Technical Service Information

FORD AOD “SQUAWK ” ON 2-3 SHIFT

Figure 1

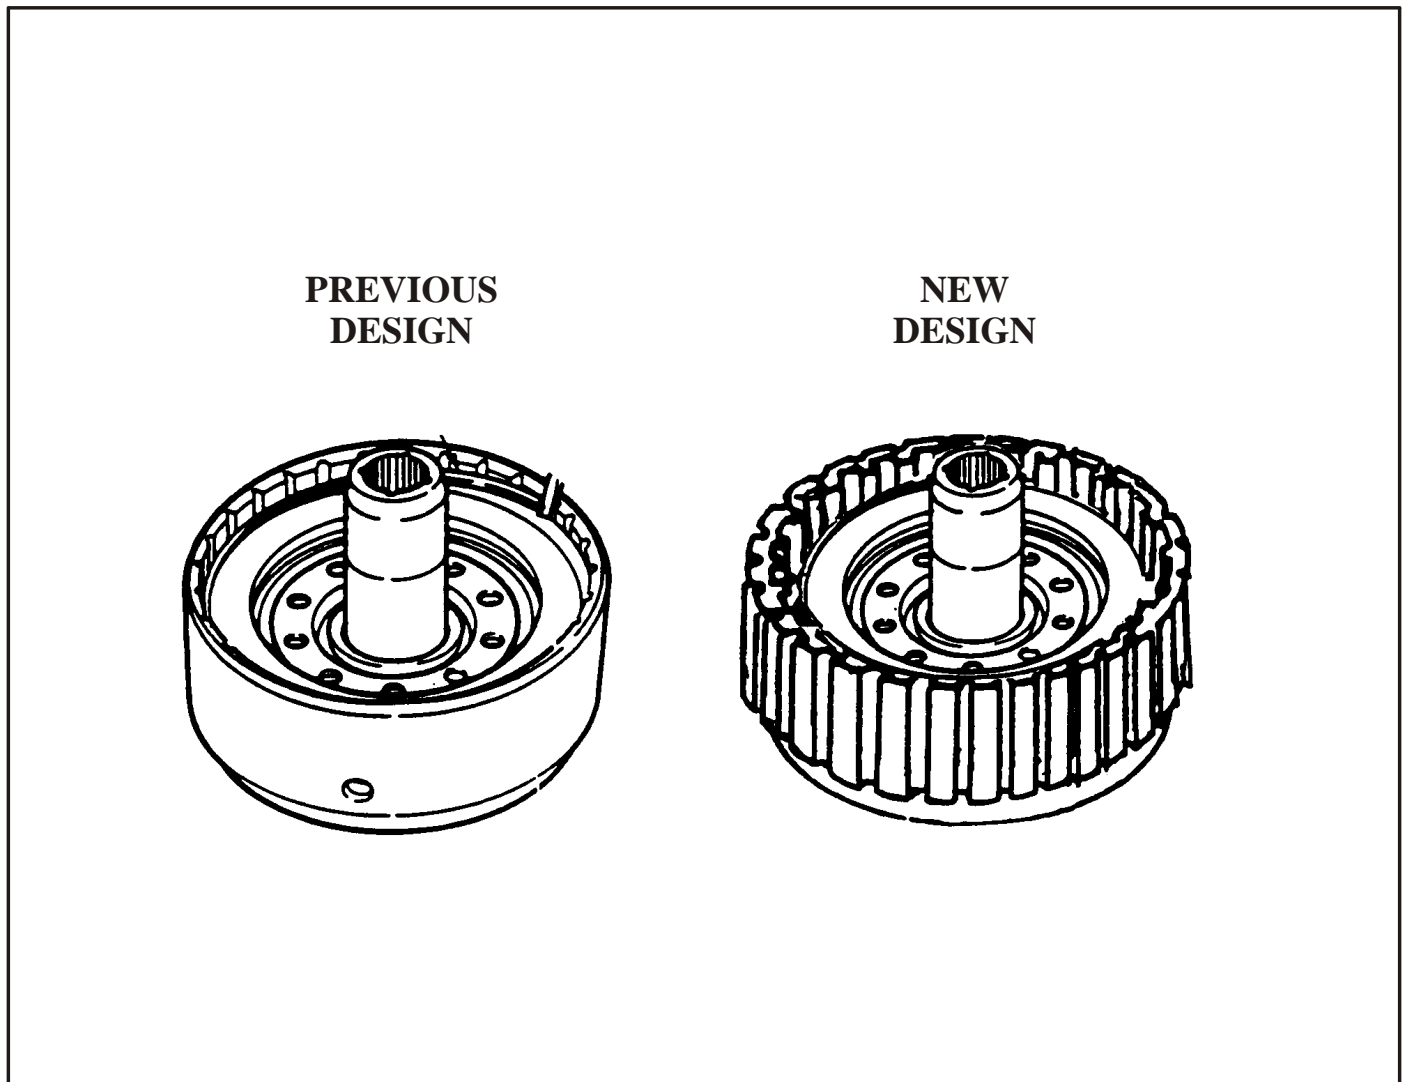
COMPLAINT: Clutch noise or "Squawk" on the 2-3 shift, in 1989 models only.

CAUSE: In 1989 there was a new design stamped steel direct clutch housing (See Figure 1) introduced, that creates the noise.

CORRECTION: Install the previous design cast steel direct clutch housing.
